U.S. Nuclear Regulatory Commission Operations Center Event Report

Event # 42151

INITIAL PART 21 NOTIFICATION - PRIME MEASUREMENT PRODUCTS, MODELS 763 & 763A PRESSURE TRANSMITTERS AND MODEL 764 DIFFERENTIAL PRESSURE TRANSMITTERS

Barton Model 763, Model 763A and Model 764 Zener Diodes

Larger Commercial Zener Diode & Smaller Similar Glass Body JANTX Zener Diode

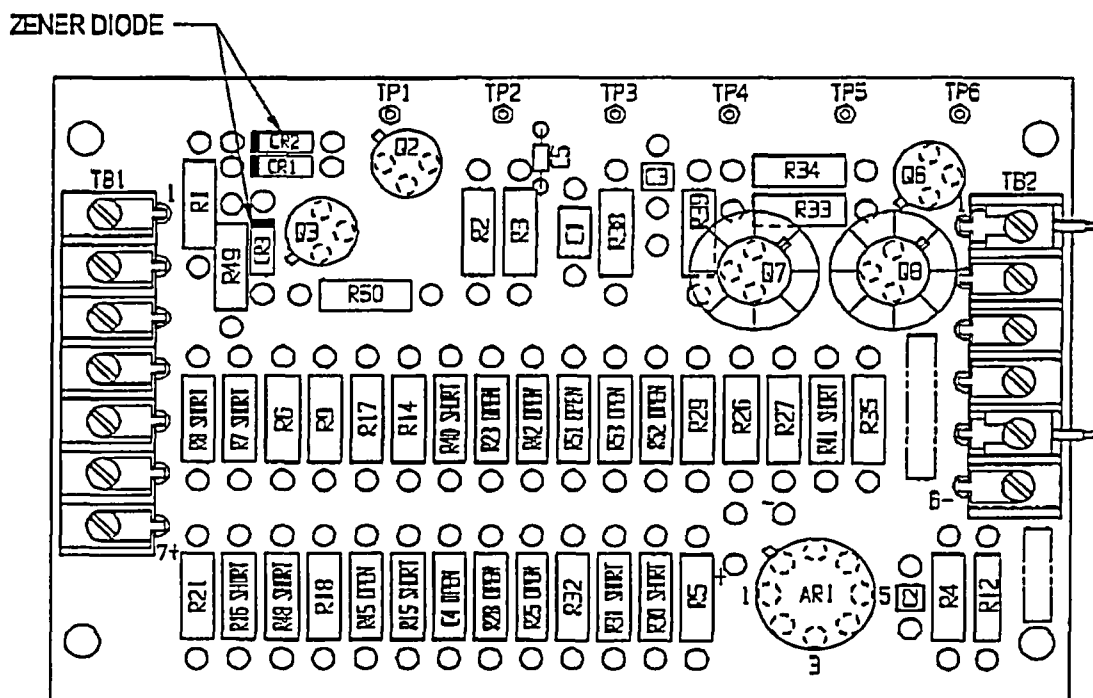
The JANTX Zener diodes are different in appearance with respect to the commercial variations. Some JANTX Zener diodes used in the recent past have bodies that are solid orange or light blue in color or clear glass. The commercial Zener Diodes that have been used have a body that is clear glass. The attached photo compares the larger commercial Zener diode (0.095" diameter X 0.275" long) with the smaller JANTX Zener diode (0.072" diameter X .155" long) that has a glass body. The existence of the commercial Zener diode can be verified by visual inspection. Remove the transmitter electronics cover and visually observe the Zener diodes at locations CR2 and CR3 as shown on the attached drawing of the circuit board.

The Zener diodes are not field replaceable, as it is necessary to electronically reestablish the calibration zero which will likely necessitate replacement of a calibration resistor. This calibration resistor is located in a very temperature sensitive portion of the electronic circuit requiring thermal performance validation.
